Fourth Quarter 2005 Progress Report
Midwest Roadside Safety Facility
Mid-States Regional Pooled Fund
January 24, 2006

Pooled Fund Consulting Summary

Midwest Roadside Safety Facility
October 2005 – January 2006

Figure 1. Bullnose – High Tension Cable Offset

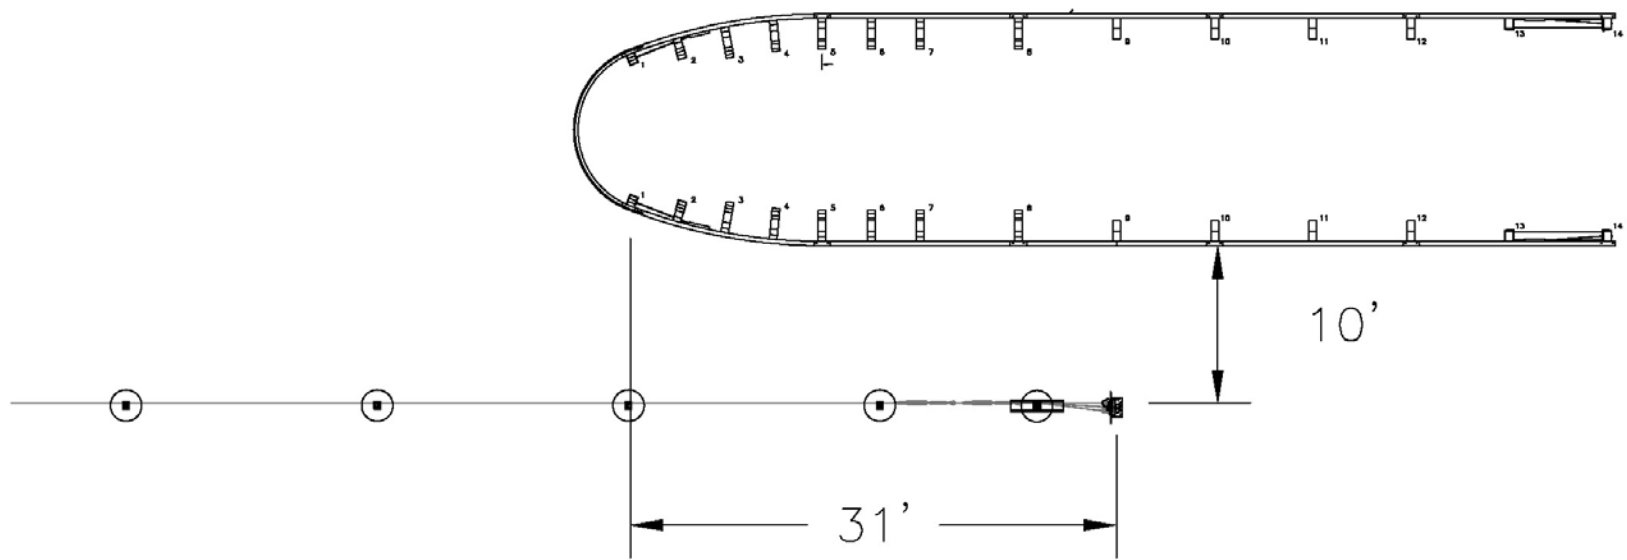
When to terminate it prior to bullnoses, or tied in behind W-beam End Treatments?

1. When to terminate it prior to bullnoses, or tied in behind W-beam End Treatments?

I reviewed the full-scale crash tests for the major high tension cable systems. All of the reviewed systems had dynamic deflections between 6.5 and 8.9 ft when impacted with the 2000P vehicle under TL-3 impact conditions. Keeping in mind that these tests were conducted on relatively short installations, we can expect slightly higher levels of dynamic deflection in longer installations. As such we would recommend at least a 10-ft lateral offset between the high tension cable barrier systems and the bullnose. In addition, we would recommend termination of the high tension cable barrier at least 31' downstream of the first post of the bullnose. This distance should be sufficient to allow the bullnose to provide redirection of a vehicle if it impacts

near the cable end terminal and gates through the terminal. See the attached pdf file for a schematic. Another alternative might be to not use a bullnose at all, but rather an end terminal appropriate for median use with a similar offset for the cable.

Figure 2. Florida PCB Transition Splice

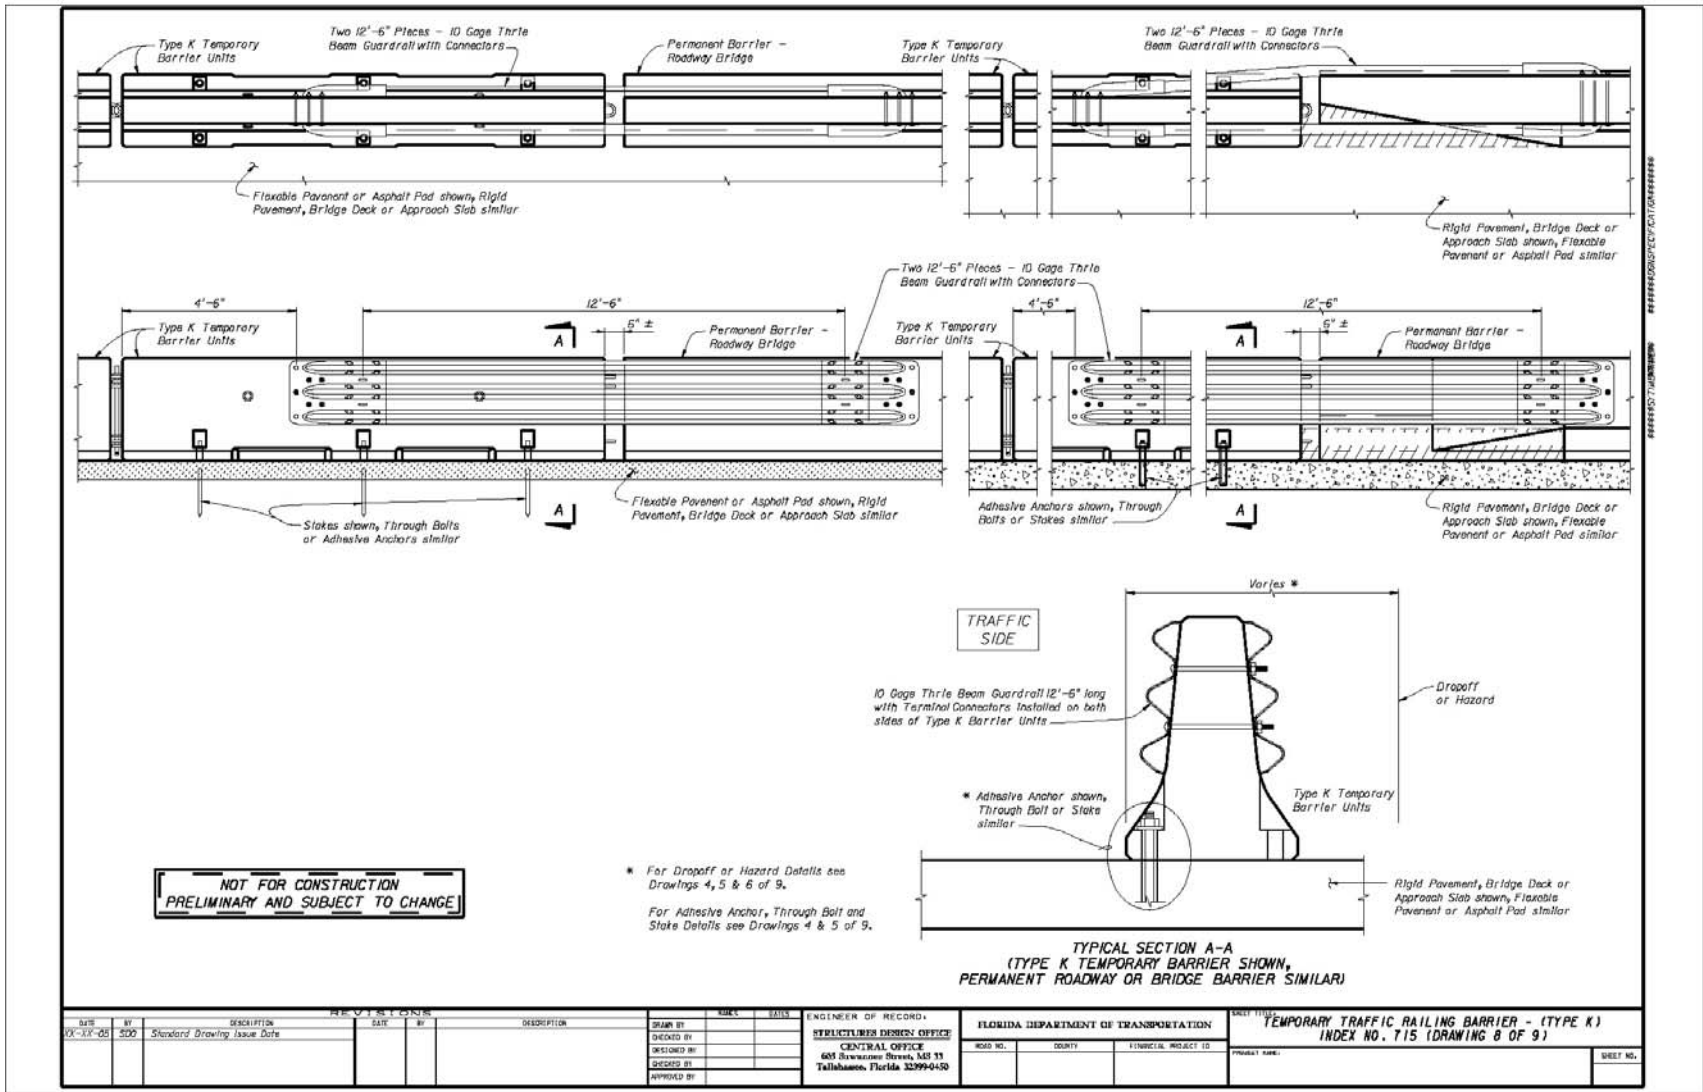
1. What size and type of bolts are used to attach the thrie beam terminal connectors to the barriers? In our drawing 8 of 9 above we've shown a through bolted connection using five 7/8" dia. HS bolts (ASTM A449 Type 1) with hex nuts and washers under the nuts and heads. This is what we use for permanent attachments of thrie beam to our concrete traffic railings. In the attached photo you sent me, it looks like some kind of big lag screw (3/4" dia.?) was used for the test installation:

Can you give me any specs or the name of a manufacturer for these lag screws/bolts? Do these screws/bolts require the use of an expansion sleeve? If we wanted to use through bolting only, do you see any problems other than fit up of the bolts and the terminal connectors on the two opposite sides of the barriers?

2. Proper lateral positioning of the FTB relative to the end of the permanent barrier is proving to be a challenge with all the different shape barriers and end transitions we currently use or have used in the past - 32" F shape (shoulder and median), 42" F shape, 32" Jersey shape (shoulder and median), 32" and 42" vertical face, corral shape, 8' F shape / soundbarrier, etc. On drawing 8 of 9 above we show two combinations: 1) FTB to permanent median barrier and 2) FTB to an old FDOT style shoulder barrier transition.

Depending on the shape and overall thickness of the permanent barrier and lateral positioning of the FTB, potential snag points could be created. We're still looking at all our possible combinations of approach and trailing end configurations. One combination with a possible snag point is shown on the upper right corner of drawing 8 of 9. If the direction of adjacent traffic is right to left on this plan view, the exposed lower end of the FTB could be a snag point. To reduce this potential I'm thinking of filling the cross hatched area with miscellaneous asphalt. If the direction of adjacent traffic is left to right on the plan view, the potential for a snag looks to be minimal.

Another problem seen in this same plan view is bending and fit up of the thrie beam guardrail on the back side of the barrier. I'm thinking of using offset blocks on the back side of the FTB

between the FTB and the terminal connector so the thrie beam doesn't have to be bent as shown. A second offset block may be needed at the end of the FTB to engage the middle portion of the thrie beam.

1. The bolts used in the full-scale test were 3/4" dia. by 6" long Powers Fasteners Wedge Bolt Anchors. We have been using these anchors quite a bit lately and have been happy with them. We use them to attach the SAFER barrier to the concrete walls of the race tracks. It does not use a sleeve. An important note on these anchors is that we used the anchors with a minimum 8" spacing between anchors. The performance of the anchors can degrade under smaller spacings. As such, you may need to change the anchor layout shown on your drawing to use the three outer holes in the end shoe and the two inner holes. This is shown in the picture you emailed me. This layout gives the 8" spacing.

As far as through-bolting the end shoe, that is fine as well. You may encounter issues hitting rebar as you mentioned.

2. Charles, as you mentioned, the snag risk at this location is not significant unless the potential for two way traffic and reverse hits is present. However, we would recommend that the potential be reduced in this situation. Ron and I discussed your suggestion to use asphalt to fill in the hatched area. We believed that this should reduce snag, but we have a couple of concerns. First, it would be important to use the fill asphalt to make a smooth and complete fill of the hatched area. The fill should completely cover the area and any gaps would be undesirable. Second, we are a little concerned about the ability of the asphalt to prevent rim and wheel of an impacting vehicle from gouging or digging into the asphalt and creating a snag hazard or exposing a corner of the barrier. A better method may be to make a simple form and place a concrete fill in the hatched area. This will be more resistant to gouging during the impact and provide better reduction of snag potential.

You can use offset blocks to eliminate the need for bending the thrie beam in this situation, but there are some things to consider. First, you will want to offset the beam from the barrier at two locations at a minimum and more would be preferable. You would want to block the area

near the joint between the barriers as well as the of the end shoe connection at minimum. It should also be noted that the use of the blockouts may introduce bending loads into the bolts or anchors used in the end connection with the blockout. Thus you may want to check and possibly increase the capacity of these anchors. I would not recommend using the Wedge Bolt anchors in this installation due to lack of bolt embedment and the potential for bending loads. Instead I would require the through-bolt option here.

I have a couple of other comments about your CAD with the four types of installations. On the top installation, the median installation, there may be some issues with reverse hits on the non-staked side of the transition barriers downstream of the permanent barrier. I think we have discussed before that impacts with the stakes on the back side of the barrier are very likely to result in increased rotation of the barrier sections and thus increased potential for vehicle instability. As such, we are not very excited about the use of the transition in the median area. However, we realize that you may have no better options at this time. Until we have investigated this issue more thoroughly, the best recommendation I can give is that we are concerned about reverse hits in this installation due to the potential increase in barrier rotation and resulting increase in vehicle instability. Another thing to keep in mind with the median installation is slopes. Do you know what kind of slopes you will be installing the barriers on??

My last comment concerns the fourth installation detail at the bottom of the page. This trailing end transition should be fine for installations only dealing with one way traffic, but on narrow highways with two way traffic, the potential for reverse hits on this installation is significant. In that case we would recommend you install the approach transition here.

Figure 5. Old FLDOT Transition Schematic

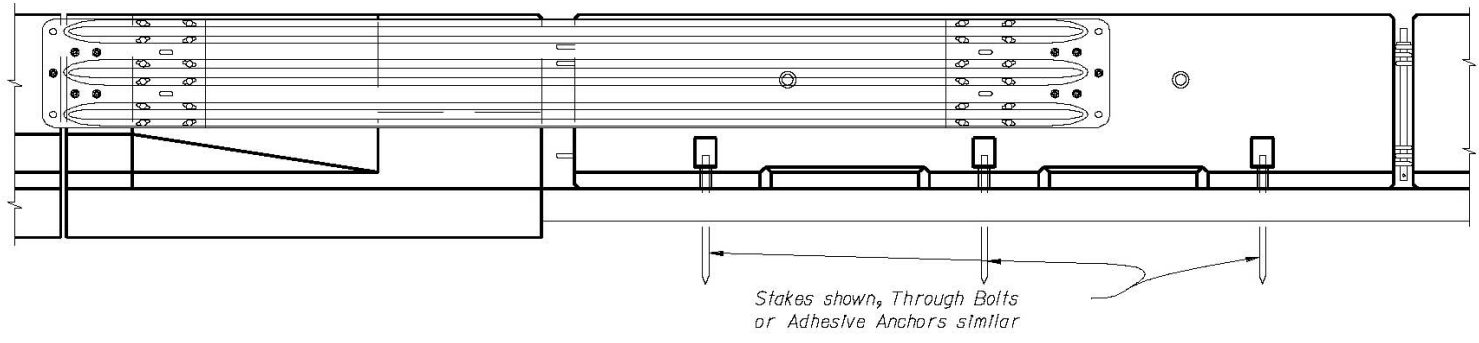
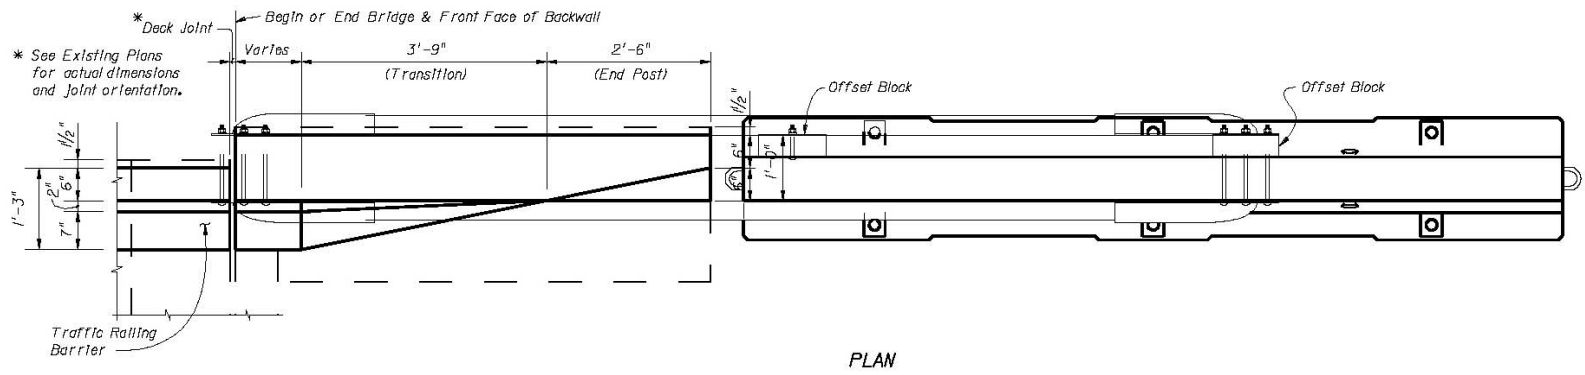
Here is a sketch that shows our old F and NJ shape traffic railing transition, an FTB and a Thrie Beam Splice:

The old W beam guardrail end shoe would have bolted up to the 2'-6" long "End Post" section. We plan to fill in the recess at the bottom of this section with concrete to reduce the snag potential for traffic moving left to right. For traffic moving right to left, we plan to leave the recess open. The Offset Blocks at the back of the FTB are there to keep the Thrie Beam straight (unbent).

The "Varies" dimension is drawn at 1'-0" but could be any length from 0' to many feet. Our problem shows up at the left end of the "Varies" dimension where the Thrie Beam Terminal Connector straddles the deck expansion joint.

We can't bolt across this joint with the Terminal Connector as thermal movements of the bridge would likely tear the connection apart. Thus we're thinking of using a 25' stick of thrie beam to get the left Terminal Connector (as seen in the sketch) up on the bridge beyond this problem area. The right Terminal Connector would be attached to the FTB at the same location as is currently shown.

1. The schematic you sent me is acceptable even with a 12" gap between the final PCB and the bridge transition piece as long as there is only one way traffic on the roadway. If traffic is moving from the PCB's towards the bridge in your schematic, then the chance for snagging on

the end of the bridge is minimal, and the three beam sections should possess sufficient capacity to hold the joint between the bridge transition and the PCB together even with the larger gap.

If the traffic is moving the other direction, you said you planned to fill the overlap area with concrete to reduce the snag potential. We agree that this is necessary and quite critical. It may be your best option to fill that area for now, but you may want to think about a redesigned transition section in the future to reduce the snag potential. In general, we would recommend not running two way traffic in this type of installation unless the snag issues can be sufficiently eliminated.

2. As far as the connection to the bridge rail on the downstream end, I agree that you do not want to straddle the expansion joint. A simple fix for this problem would be to shift the three beam sections upstream or downstream as needed to prevent straddling the deck joint. Shifting the three beam 12"-18" in either direction should not have a large effect on performance, and it would be simpler and cheaper than using a 25' long section to guarantee that you extend past the joint. For the installation in the schematic, you could shift the three beam sections upstream a few inches until the end shoe was positioned on the flat face of the end post/transition piece. We would probably prefer this shifting of the three beam rather than using the longer section.
